# MANDATORY SERVICE BULLETIN

Reference: MFSBM-2501 Rev 00

Mandatory Service Bulletin - Kit for STC SA011869WI

Figure 1: Affected Area

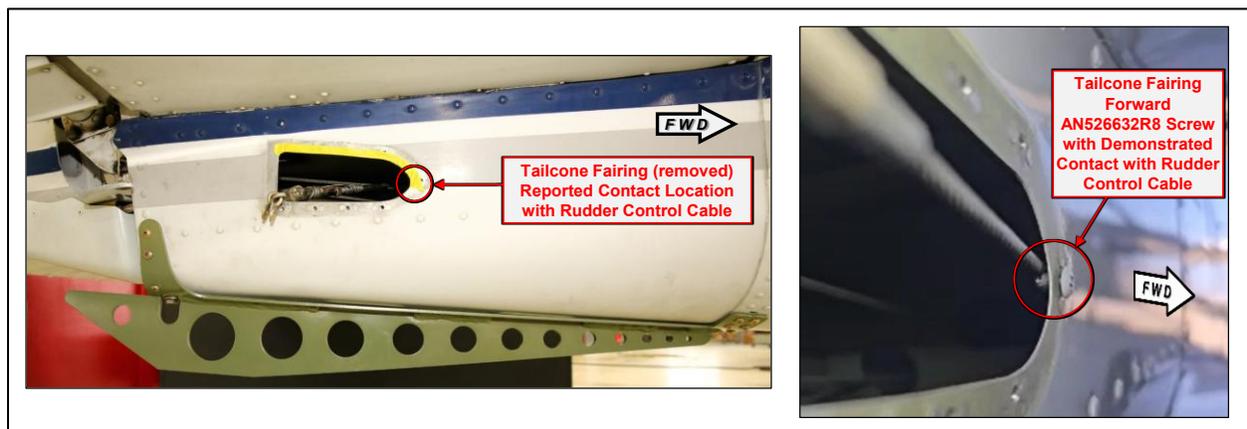
There is a potential safety issue regarding the installation of the Tail Tie-Down Assembly interference with the rudder control cable. Two incidents have been reported in which the installation of this modification results in the rudder control cable contacting a fairing screw installed by this Kit. This condition could result in severance or fraying of the cables with loss of rudder control. Figure 1 identifies the area in question.

*Figure 2: Screws to Remove*

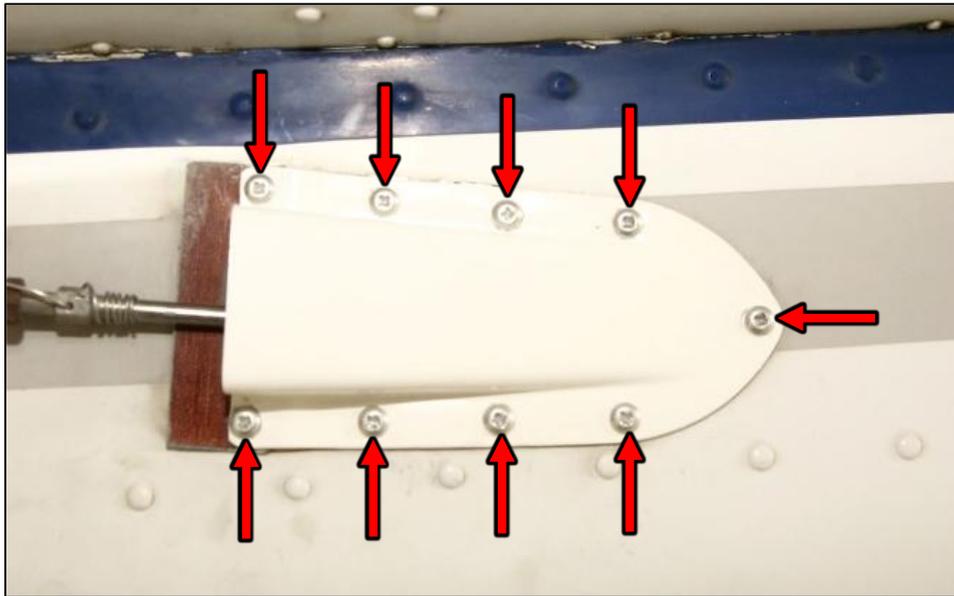
- (1) Reference 16-020-AE3302 Rev 01 (Ref [4]) page 3-17, figure 3-19, "Tail cone Faring, Installed."
- (2) Remove 9x AN526632R8 screws and fairing with #2 Phillips screwdriver.

*Figure 3: Tail Cone Faring Modification*

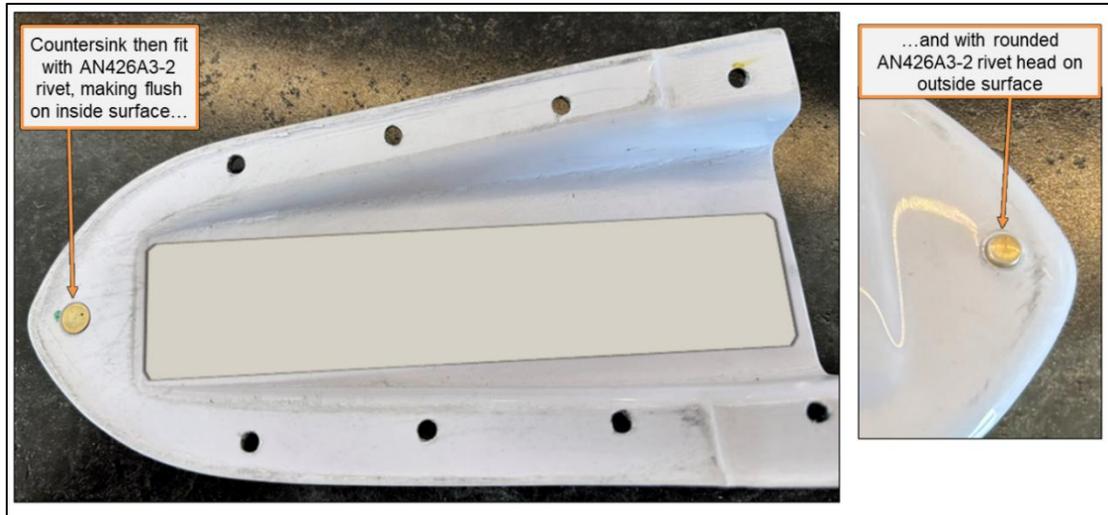
- (4) With the tail cone fairing (for both the plastic and metallic versions), countersink the inside of the forward-most rivet hole. Fit one AN426A3-2 rivet, so as to make flush with the inside face of the fairing with the round head on the outside (Figure 3). All riveting workmanship is to be performed in accordance with AC 43.13-1B Chapter 4, Section 4, Paragraph 4-57.

*Figure 4: Tail Cone Faring, Installed*

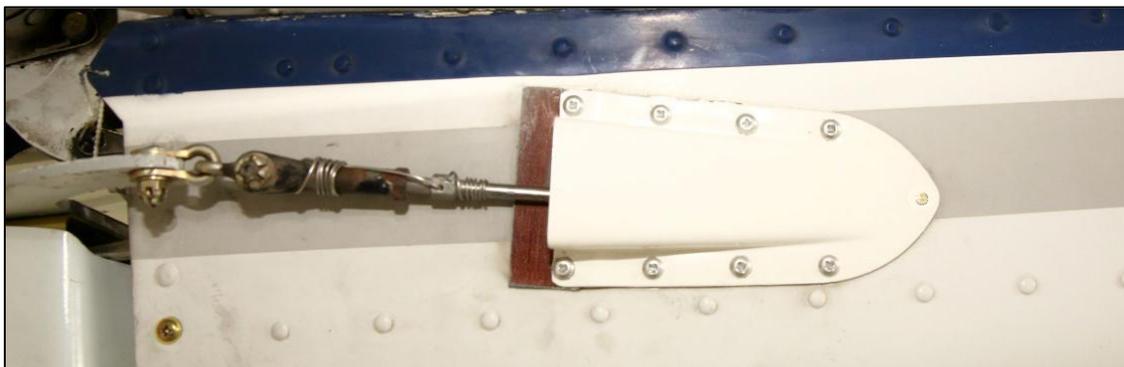
- (5) Drill off forward center MS21069L06 nut plate and leave uninstalled
- (6) Reinstall the tail cone fairing and rub strip using eight AN526632R8 screws (Figure 4).

**NOTE:** Pass the aircraft rudder cable through the tail cone fairing before installation. Reattach the aircraft rudder cables to the rudder (Figure 4) using retained hardware. Tighten castellated nut and install a new cotter pin. Ensure rigging routing and tension is correct in accordance with the aircraft's maintenance manual.
